## ADDENDUM #2

Reference: **UNG Camp Williams RTI Building 303/304 Addition, 05215480**

ADDENDUM #2 General Questions and Answers  
UTAH NATIONAL GUARD  
BUILDING 304 ADDITION  
CAMP W.G. WILLIAMS  
DFCM Project # 05215480

**8** **ROOF TRUSS BEARING ON STUD WALL DETAIL** **SEE 10** NO SCALE

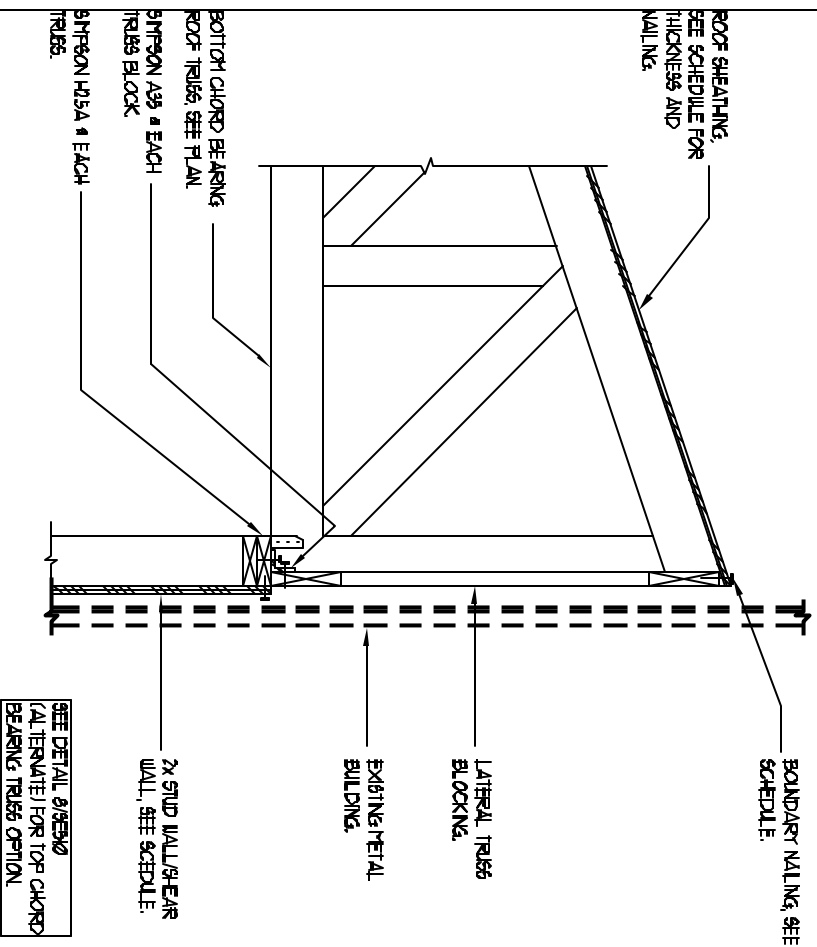
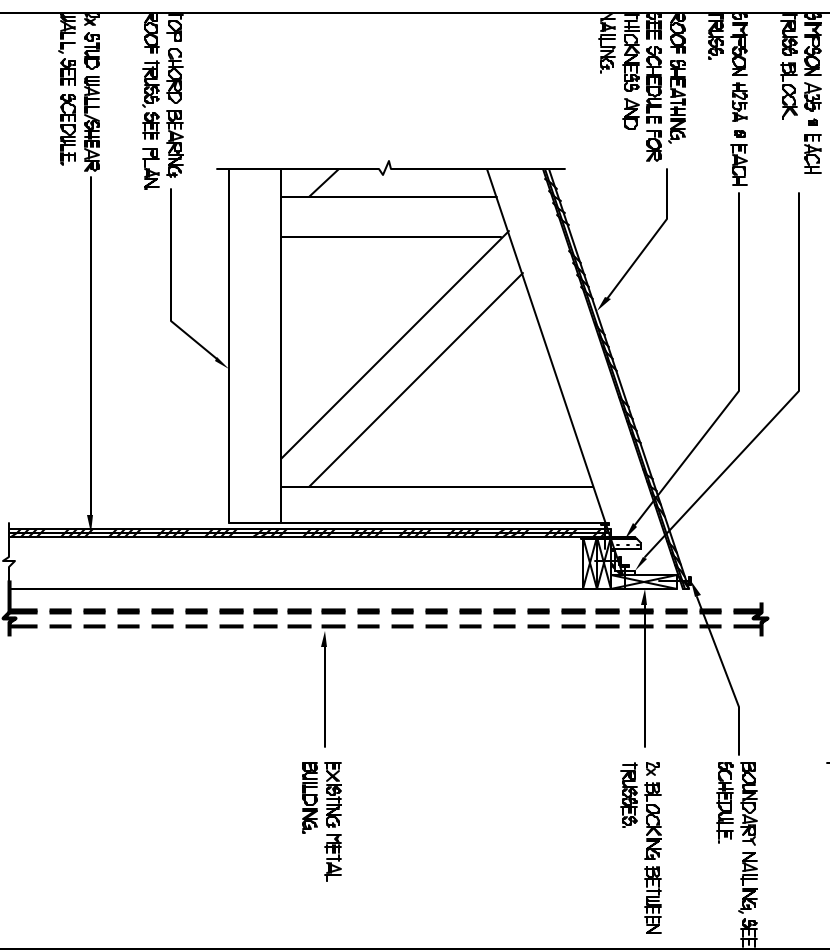
1. Can the 16' tall wall that supports the east end of the trusses be sheathed on the inside instead of the outside?

**Reply: Attached is an option to Detail 8/SE510. This allows the contractor to choose to build the exterior wall at the 10'-0" height with bottom chord bearing trusses and truss blocking between the trusses with the stud wall sheathed on the exterior side on the new addition, or to change the trusses to a top chord bearing and frame the walls up to the 16'-0" elevation with 2X blocking between trusses and sheath the wall on the inside face of wall. Both options require a 2x6 stud @ 16" on center.**

**Either option is acceptable. See attached drawings SE510 and SE102**
